CRMC DECISION WORKSHEET

2025-06-057

STATE OF RHODE ISLAND
COASTAL RESOURCES MANAGEMENT COUNCIL
 STAFF REPORT TO THE COUNCIL

Applicant's Name:	Daniel Cromie & Susan Egan Cromie
CRMC File Number:	2025-06-057
Project:	New residential boating facility (fixed pier, ramp, float)
Location:	82C Point Avenue; South Kingstown: Plat(s): 82-4; Lot(s): 32
Water Type/Name:	2, Point Judith Pond (Snug Harbor), Low Intensity Use
Coastal Feature:	Fringe coastal wetland/beach backed by coastal bank fronted by stone seawall
Plans Reviewed:	Eight sheets entitled "Proposed Residential Dock, 82C Point Ave, South Kingstown.." dated Jan 6, 2025 with Sheet 4B dated August 14, 2025 by Russell J. Morgan, RPE and "Boundary/Topographic Survey, Point Avenue, AP 82-4, Lot 32, South Kingstown.." dated 11/25/24 by Matthew Insana, PLS.
Recommendation:	NO OBJECTION

Figure 1: Site location, 82C Point Avenue, South Kingstown AP 82-4, Lot 32**B) APPLICABLE 650-RICR-20-00-01 REDBOOK STANDARDS:**

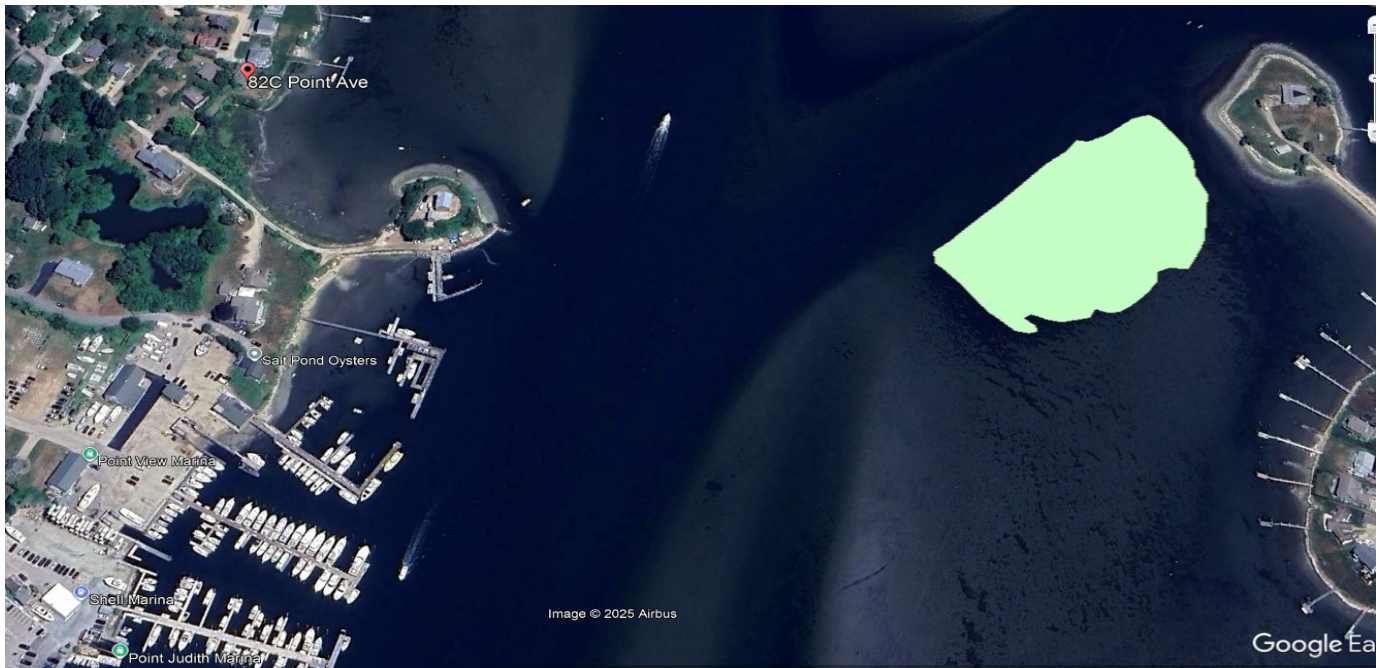
- 1) This project site is located on the western shore of Point Judith Pond, separated from the Snug Harbor/ Jerusalem commercial areas to the south by a peninsula (Figure 1). The parcel is surrounded by residential development with coastal wetland abutting to the south and fringe wetland to the east. The coastal feature is the coastal wetland backed by coastal bank and/or coastal beach/wetland backed by stone seawall. Parcels to the north have pre-existing docks.
